ADDENDUM TO THE CONTRACT

DOWNTOWN STREET IMPROVEMENTS – PHASE IIIA Contract No. BE19-112

ADDENDUM NO.: ONE

December 31, 2018

SHEET NO.
C.301
11
of
19

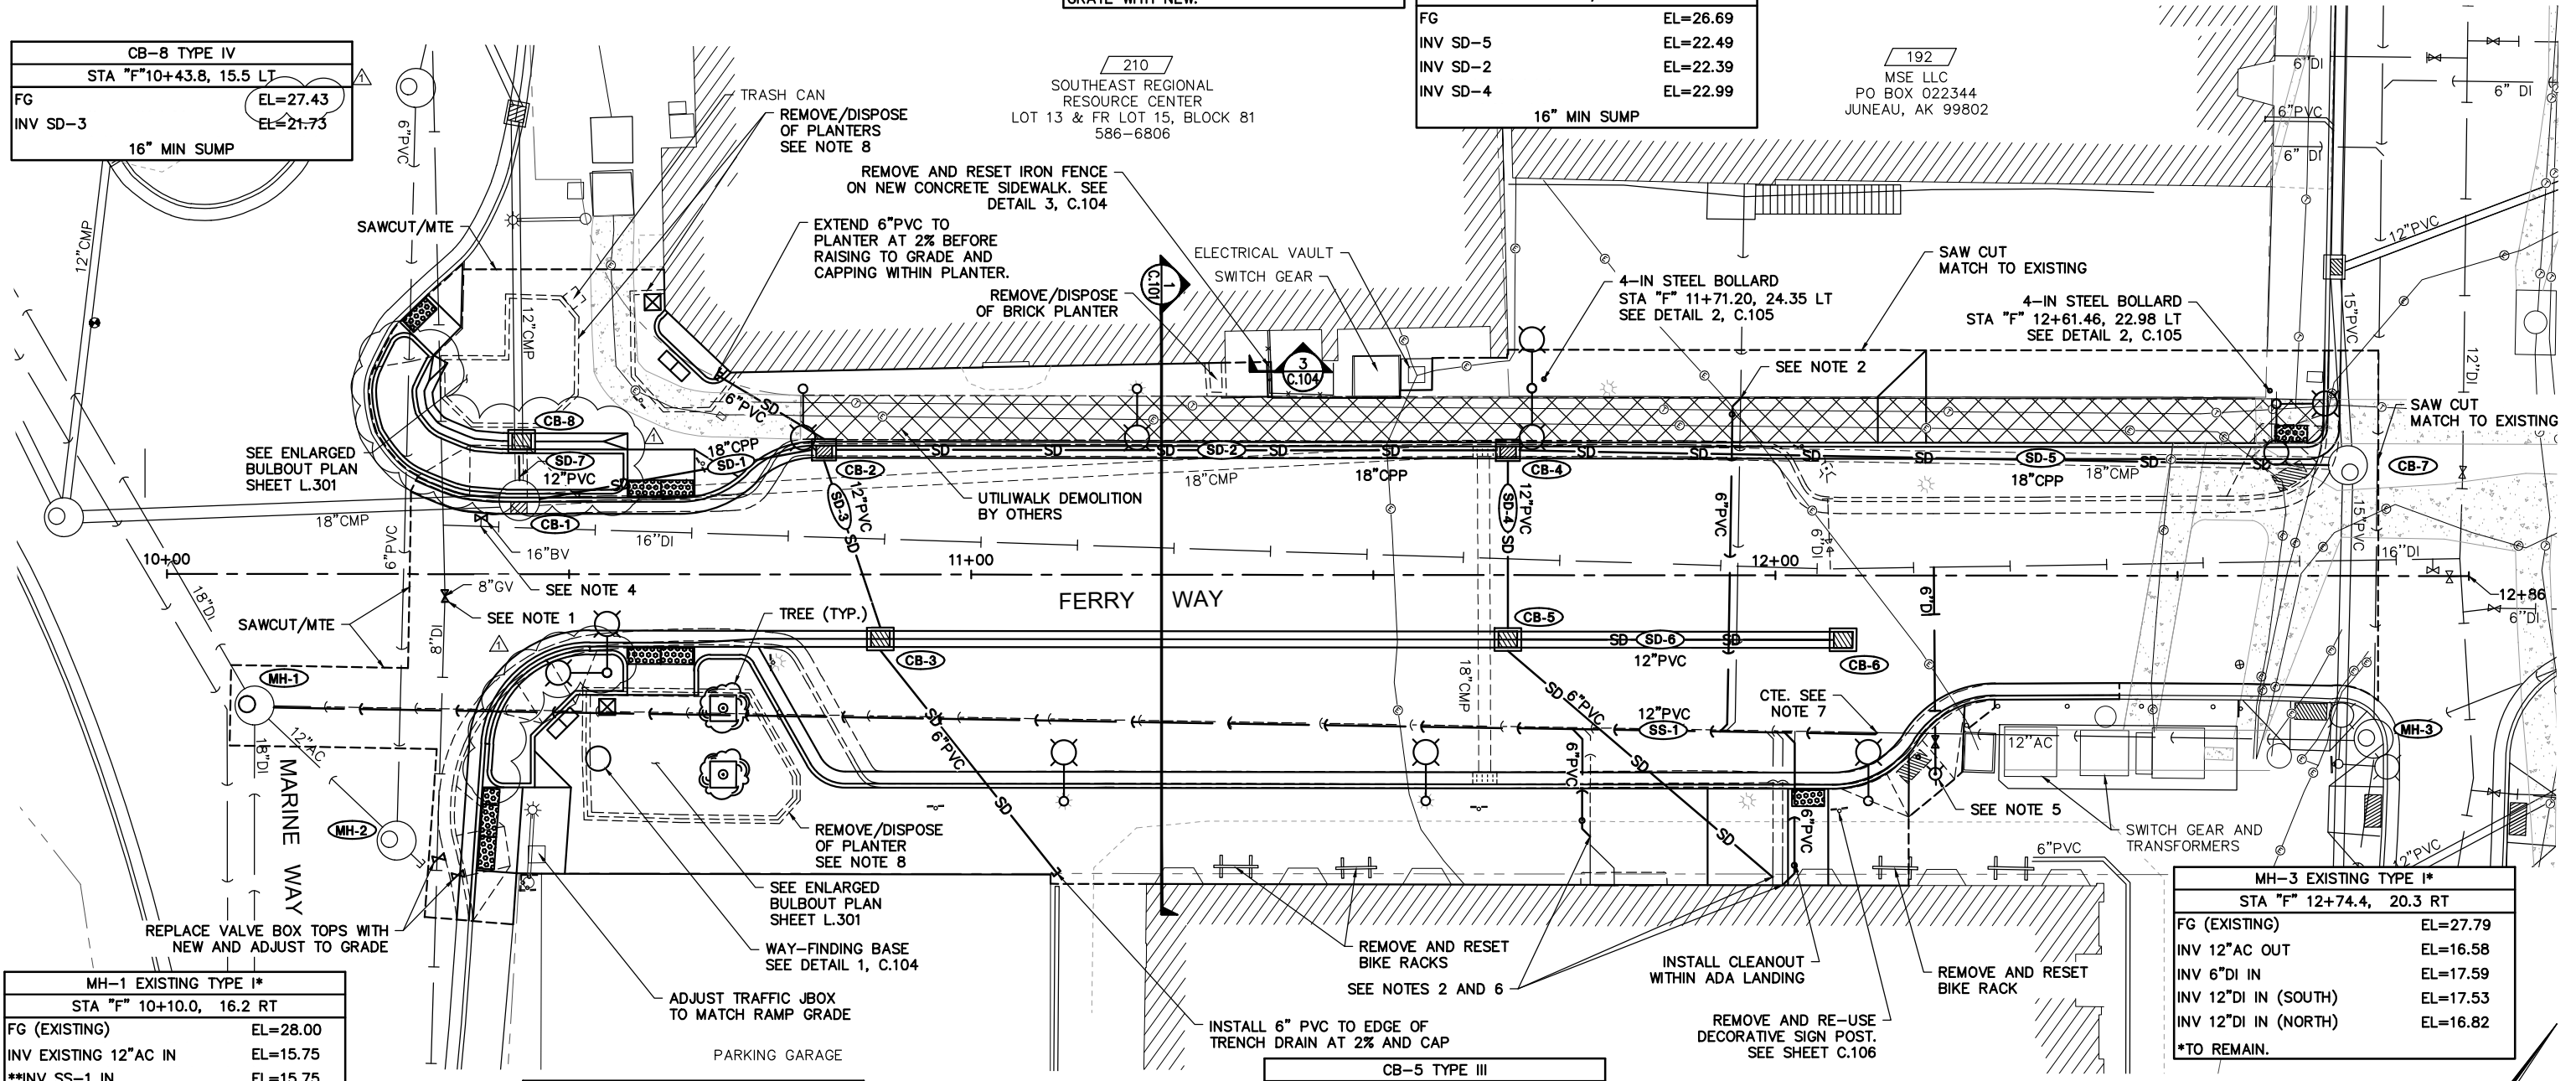
- Item No. 1 SHEET C.105, SUMMARY TABLES AND MISCELLANEOUS DETAILS, Catch Basin Frame and Grate Summary Table, **change** the frame and grate for CB-8 **to** an OF SM43.
- Item No. 2 SHEET C.301, PLAN – FERRY WAY STA "F" 10+00 TO STA "F" 12+86, **replace** in its entirety with the attached SHEET C.301. Changes include a revision to the finished grade for CB-8 and the addition of 29.5-ft of Type III Valley Gutter adjacent to CB-8.
- Item No. 3 SHEET C.501, ENLARGED PLAN - FERRY WAY BULBOUTS AND MARINE WAY CROSSWALK AT SEWARD STREET, **replace** in its entirety with the attached SHEET C.501. Changes include minor revisions to grades within the Ferry Way Bulbouts, and the edition of a Type III Valley Gutter behind the northwest bulbout planter.

ADDENDUM ONE
SHEET NO.
C.502
14
of
19

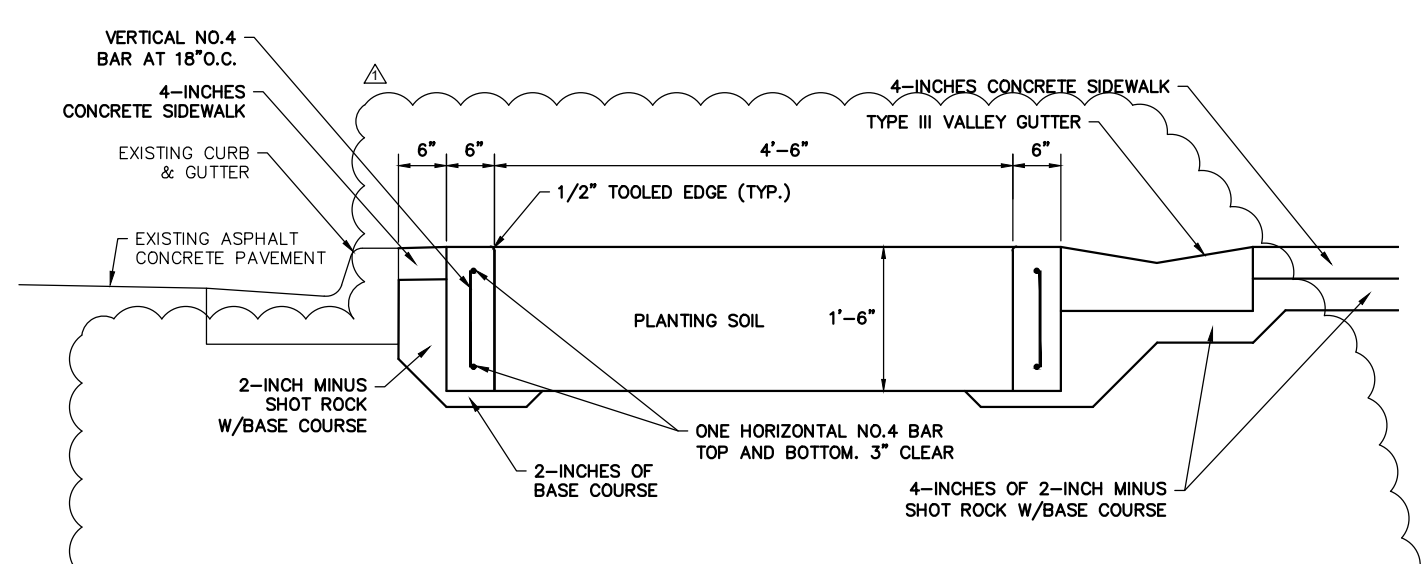
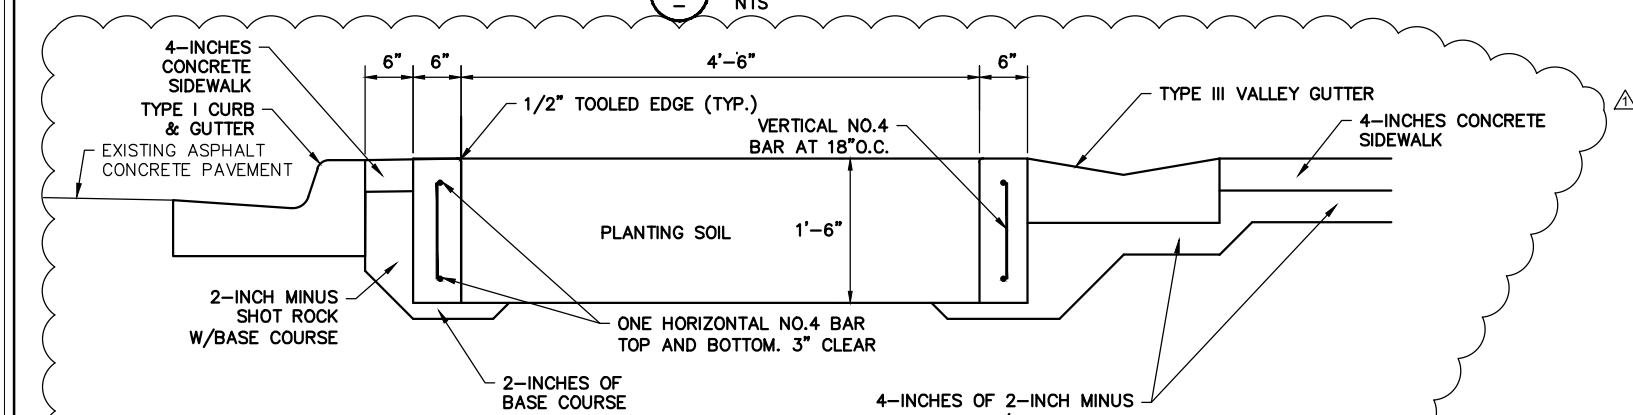
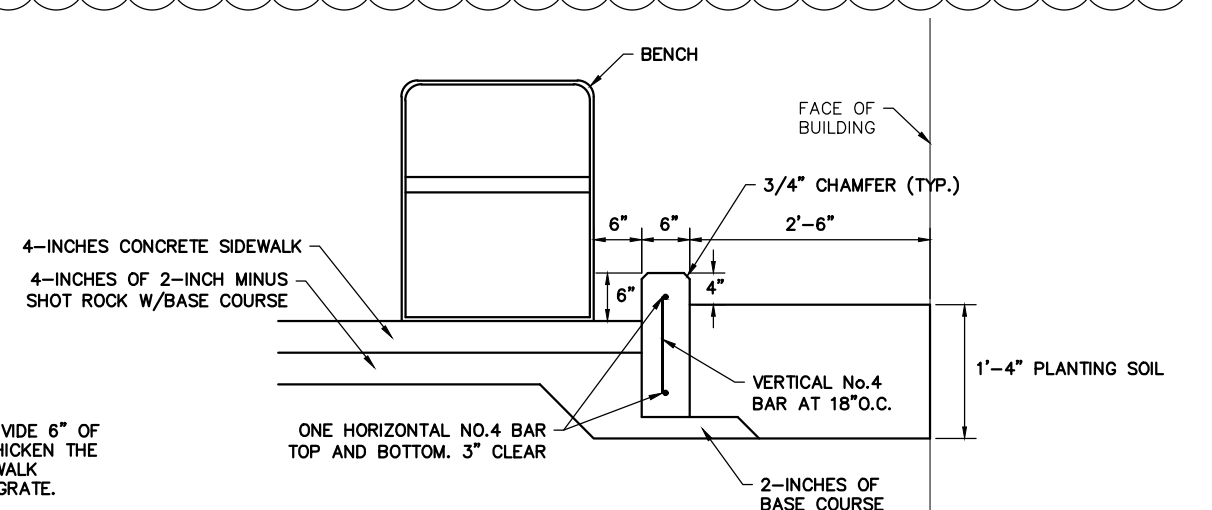
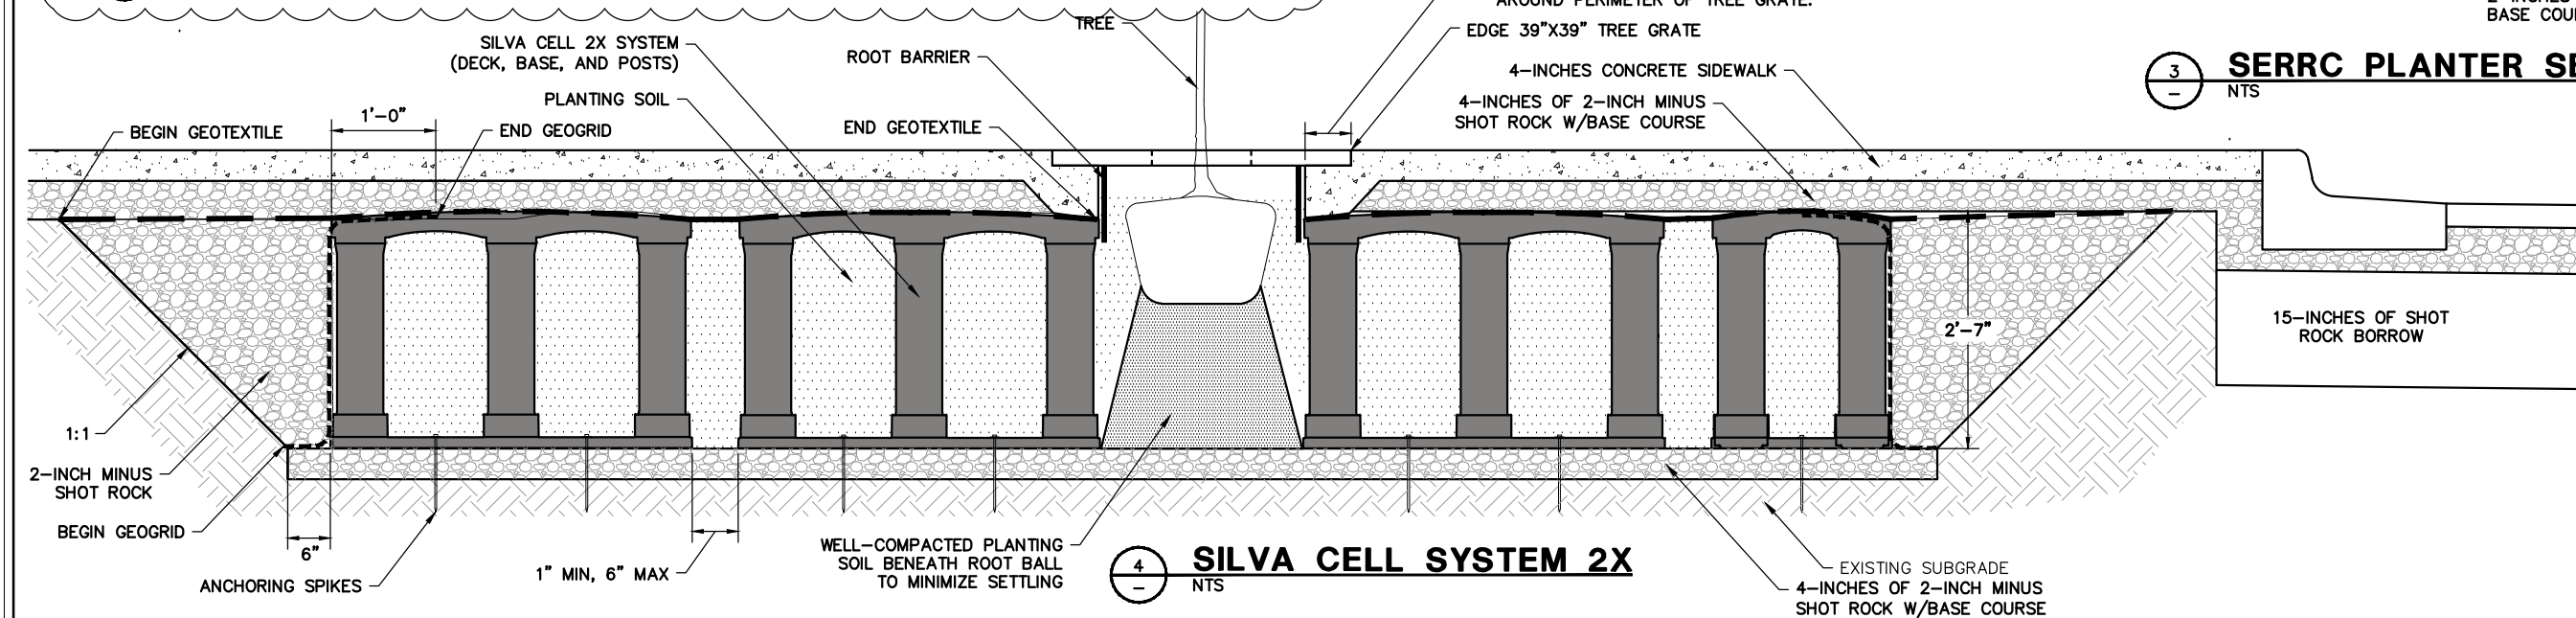
- Item No. 4 SHEET C.502, BULBOUT LANDSCAPING DETAILS, **replace** in its entirety with the attached SHEET C.502. Changes to Sections 1 and 2 include revisions to the planter walls and planting soil. Section 4 was added to depict the addition of the Type III Valley Gutter behind the new planter where new Type I Curb and Gutter is to be constructed.

E.001

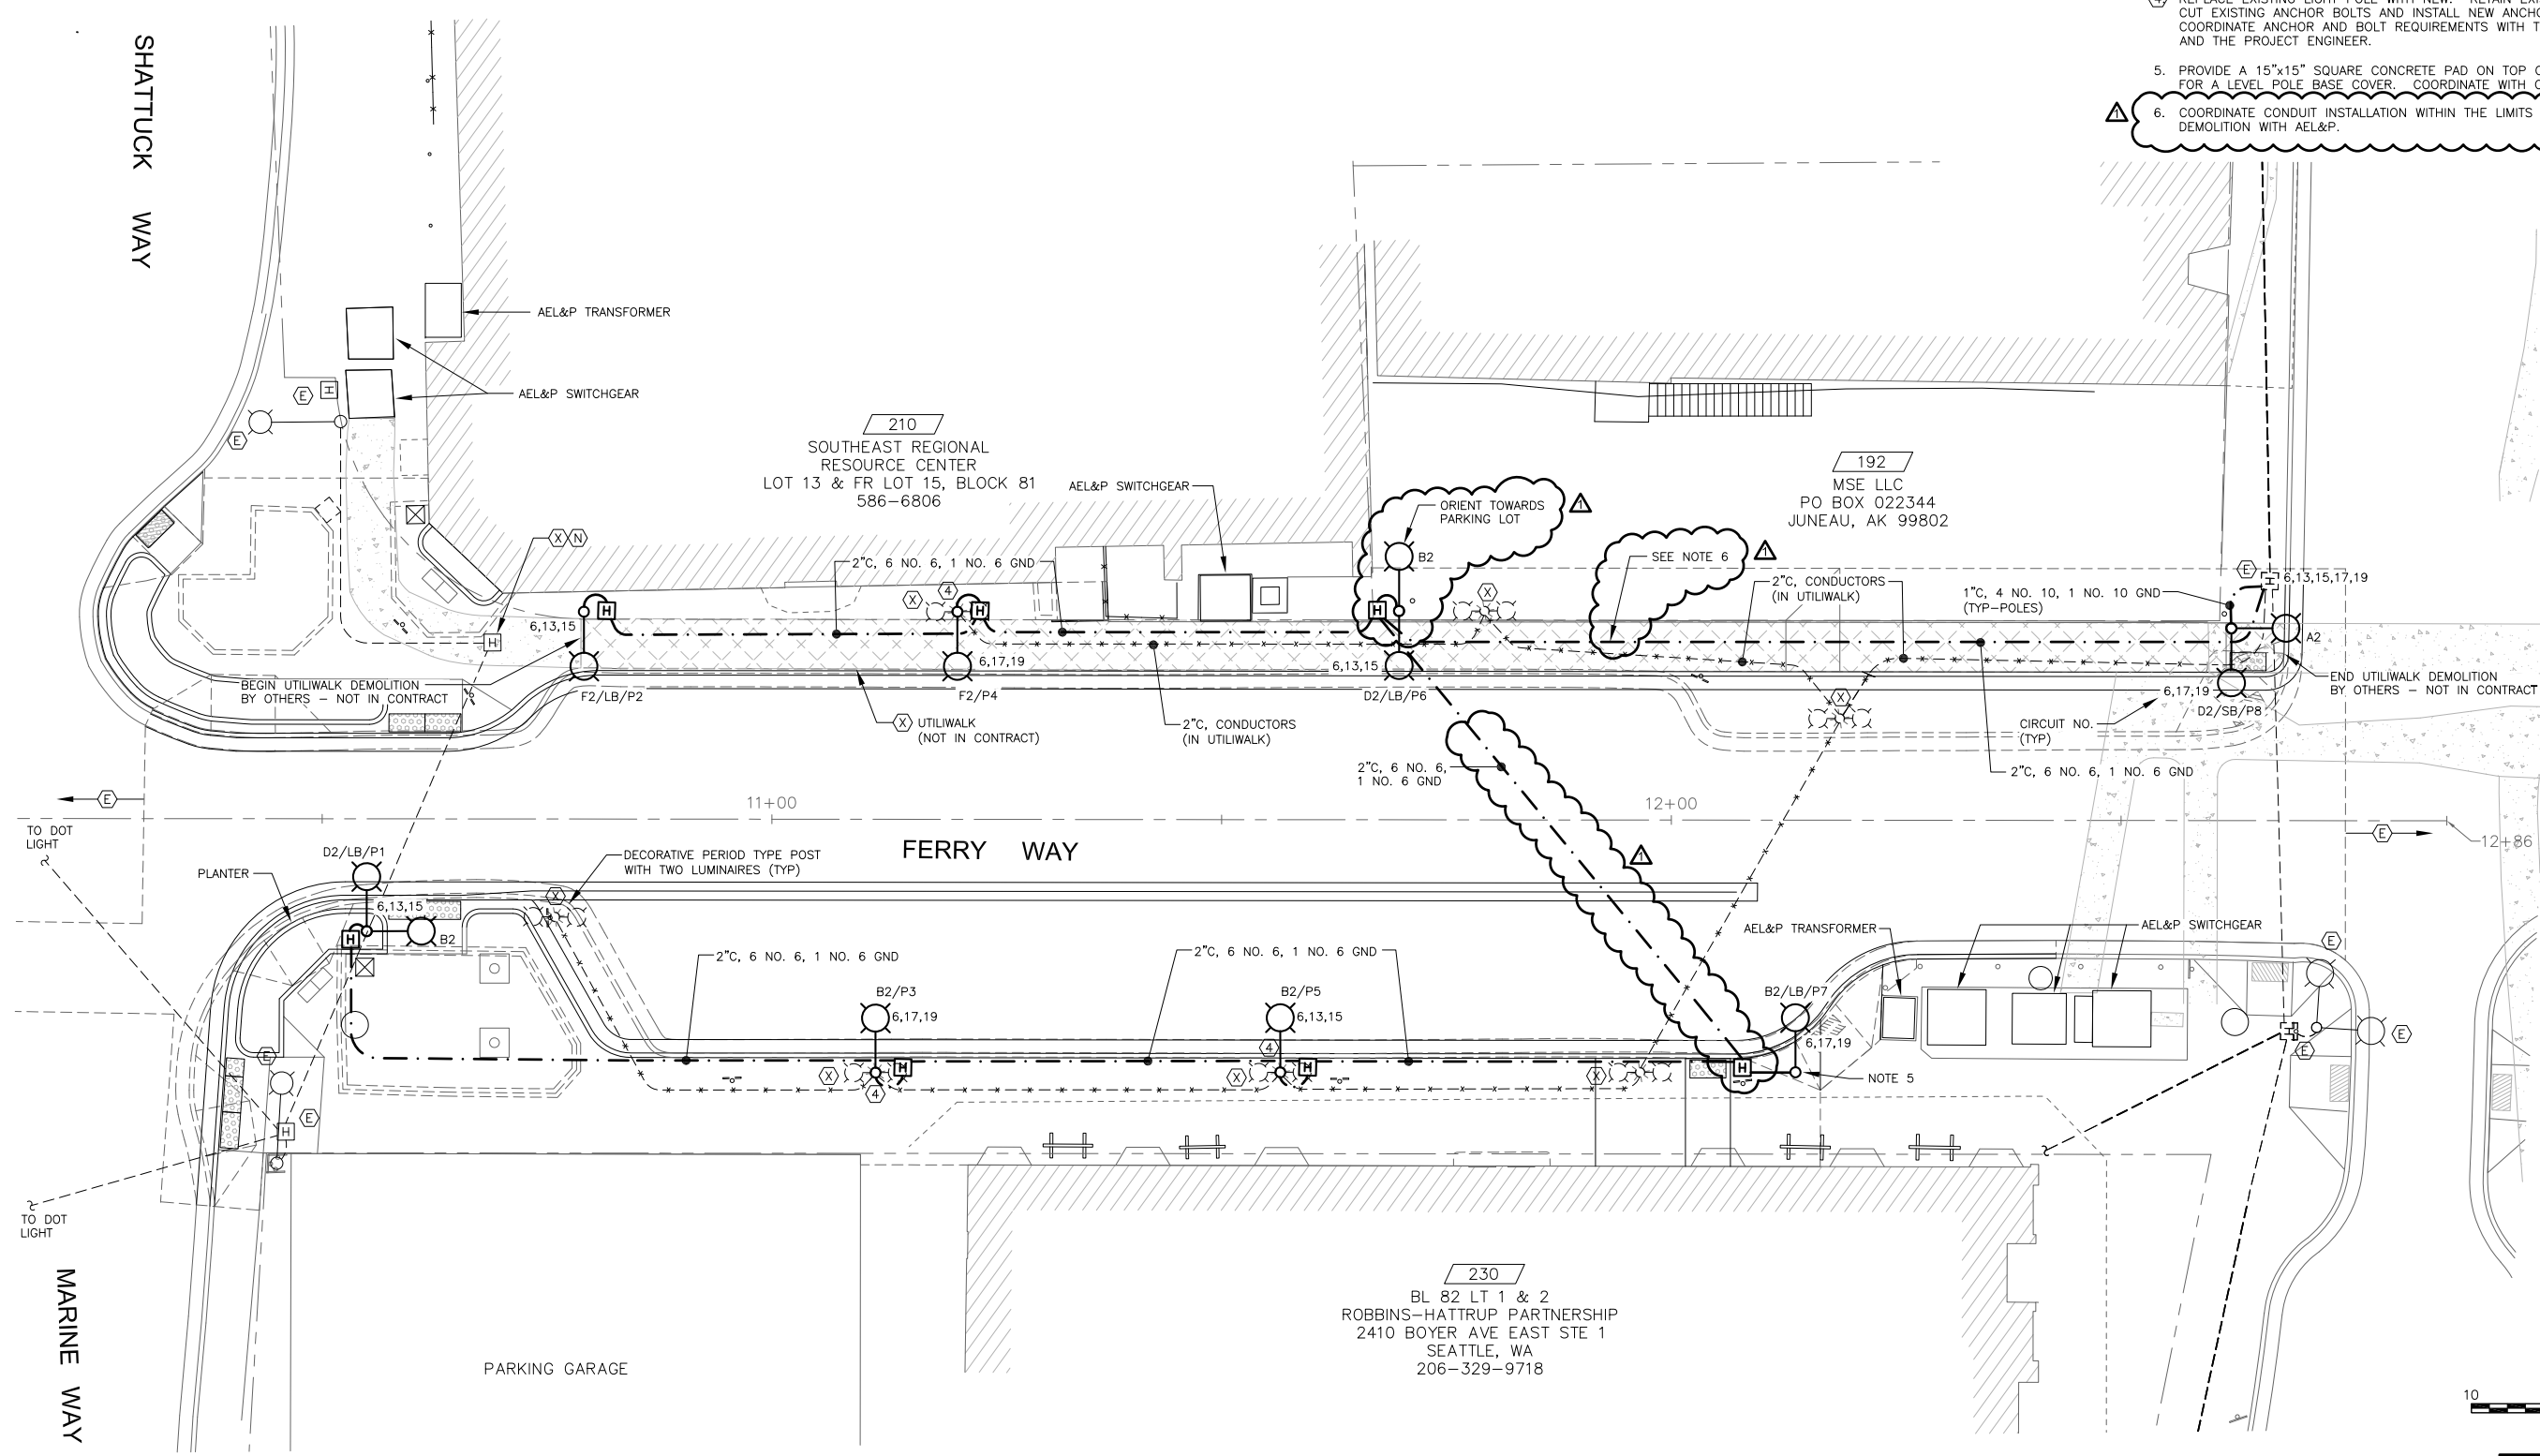
- Item No. 5 SHEET E.001, LEGEND AND LUMINAIRE SCHEDULES, **replace** in its entirety with the attached SHEET E.001. Within the "Light Pole Stationing Schedule", revisions were made to the top of base elevation for light pole P1, and a second light fixture was added to light pole P6.

NOTE: TOP OF POLE P1 BASE TO MATCH THE PLANTER WALL.
